**BSR/ASHRAE Addendum t
to ANSI/ASHRAE Standard 15-2019**

Proposed Addendum t to Standard 15-2019, Safety Standard for Refrigeration Systems

**First Public Review (September 2022)
(Draft shows Proposed Changes to Current Standard)**

Addendum t to Standard 15-2019

Figure 7-1

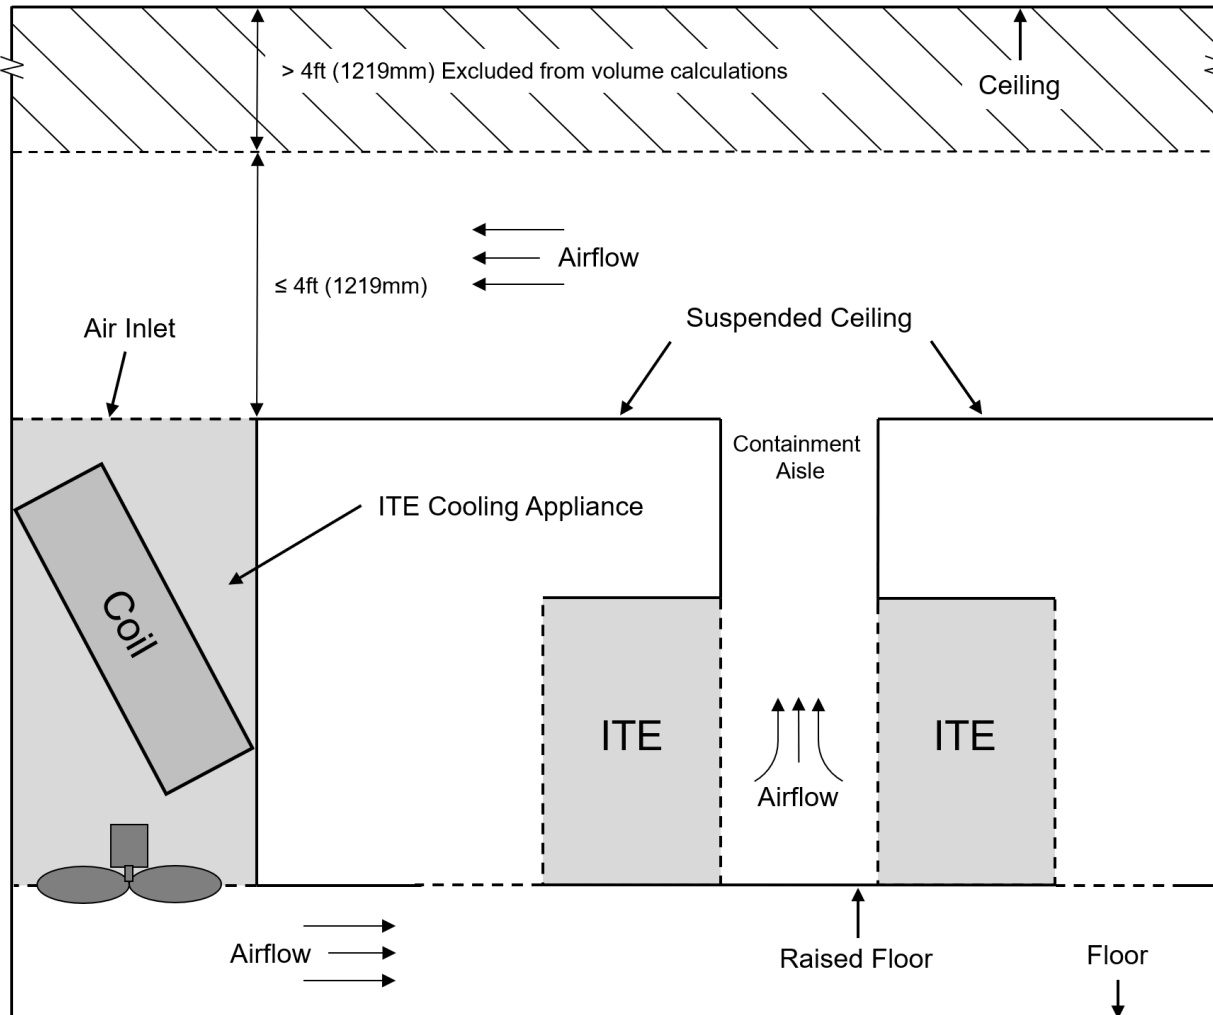
***7.3.3 ITE Room Volume Calculations.** The effective dispersal volume (EDV) of an ITE room shall comply with Sections 7.3.1 and 7.3.2, except as modified by Section 7.3.3. The maximum height permitted to be included in the EDV shall be 4.0 ft (1.22 m) above the highest duct opening. Underfloor spaces utilized in airflow movement shall be permitted to be included in the EDV.

A7.3.3. The figure below is one example of an ITE room and the application of ITE cooling appliance. ITE room orientation of hot aisle containment, suspended ceiling, and raised floor, as well as their presence, may differ from that shown in the figure. Direction of airflow may differ from that shown in the figure. The ITE cooling appliance may be located within the ITE room or outside the ITE room and ducted to the space.
